La Marzocco Technical Bulletin #105

New GS3 Displays and Firmware

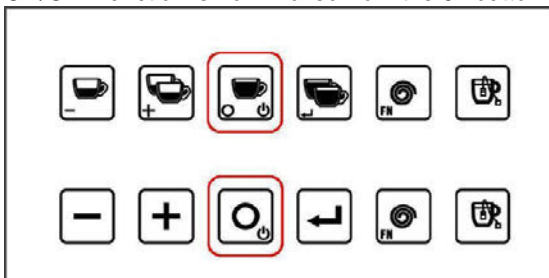
This bulletin is to inform you of some improvements La Marzocco has made to the GS3 displays. The improved button configuration is as follows:

ON/OFF function is now moved from the 6th button to the 3rd:

The new displays and keyboards will work only with new firmware versions: AV - 3d5LuFam_116

MP - 3d5LuPad_106
